HARVARD UNIVERSITY

INSTITUTIONAL MASTER PLAN AMENDMENT

For the First Amendment to the 2013 Institutional Master Plan for Harvard University's Campus in Allston
Science and Engineering Complex

January 2016
Revised April 2016

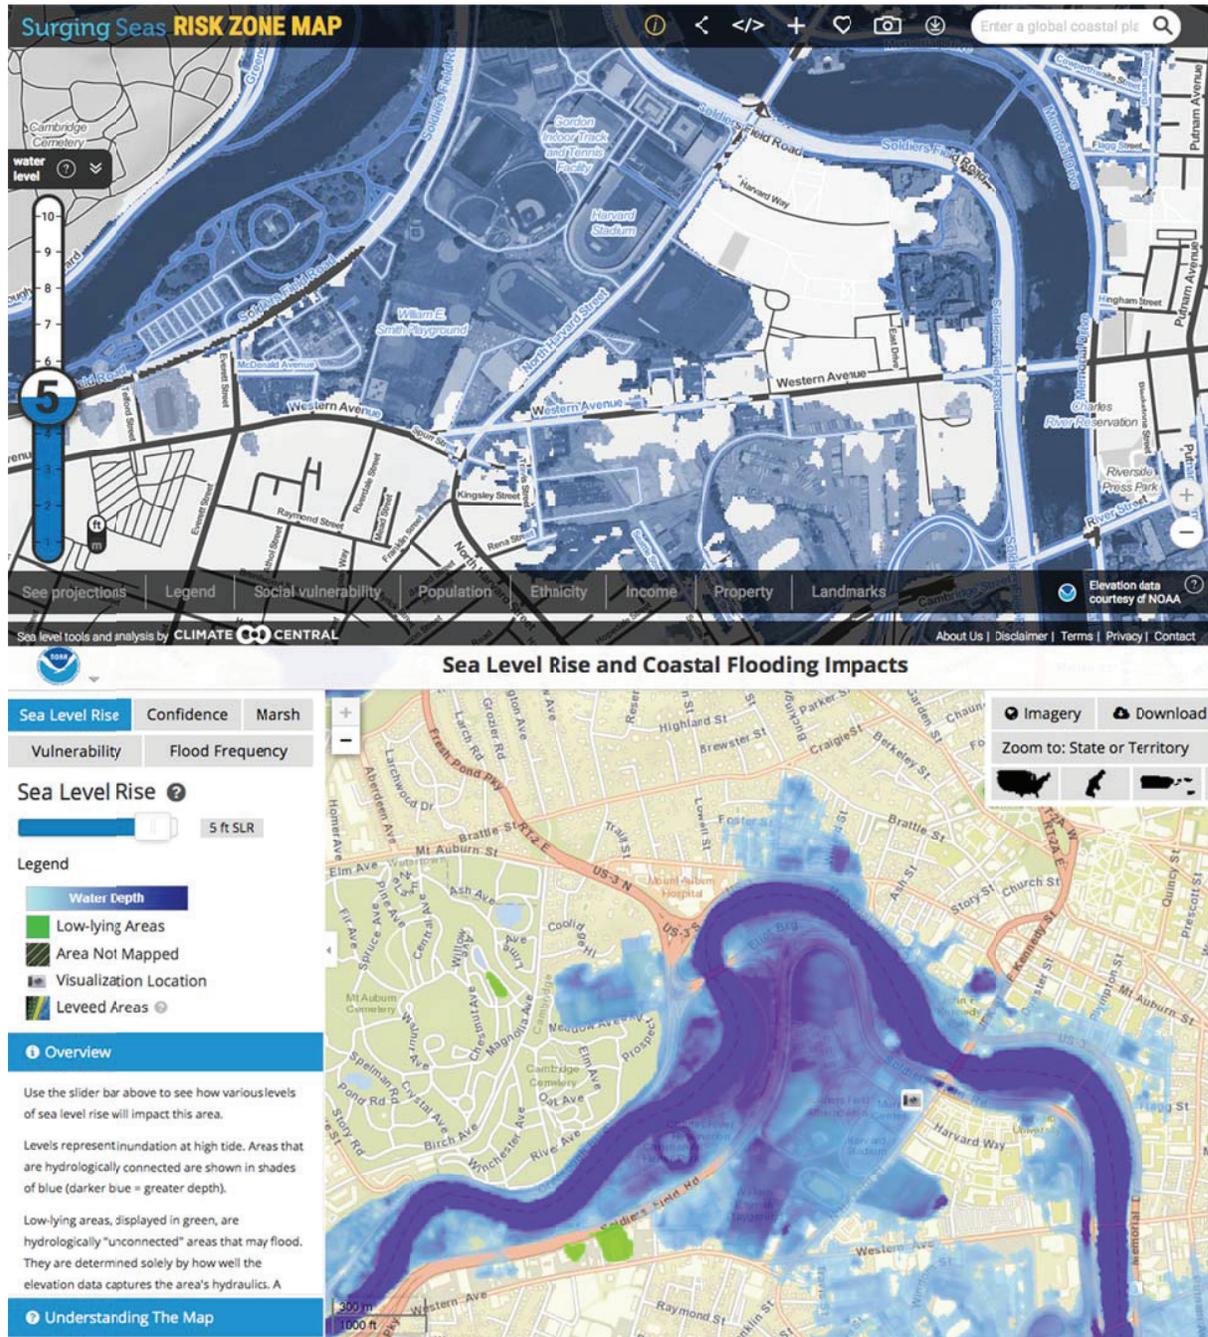
Fig 1.1 and 1.2 : (upper panel) Flood map from City of Cambridge of the combined effects of a storm surge, inland flooding and sea level rise resulting in a Mean High High Water +5' flood. Such a flood is projected to occur by mid- to late-century, with a 25% probability of occurring before 2040 (equivalent to flooding from Hurricane Sandy if it hit Boston during high tide).

Fig 1.3 CRWA's concept sketch (from 2007) for a Greenway connection from the residential neighborhood to the Charles River along a historic stream corridor overlaid with existing storm drain network underground.

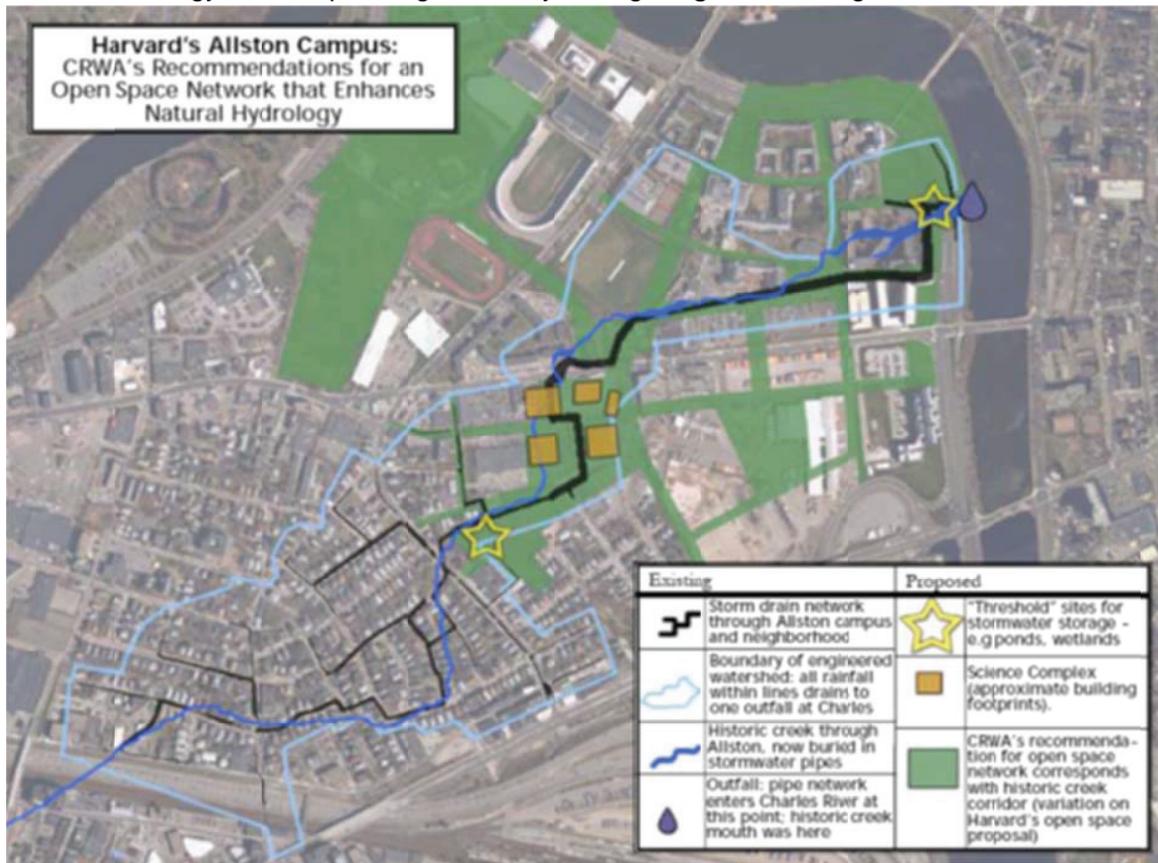
As shown in Fig.1.3, a concept sketch developed by CRWA in 2007 as part of its master plan recommendations to Harvard, the greenway connecting the Honan Library to the river is essential not only for providing improved public access through the campus but also for improving the health of the river. Given the flooding that occurs in the neighborhood, following even minor rain events and poor water quality in this section of the Charles, the greenway is an effective strategy for incorporating resiliency through regional scale green infrastructure.
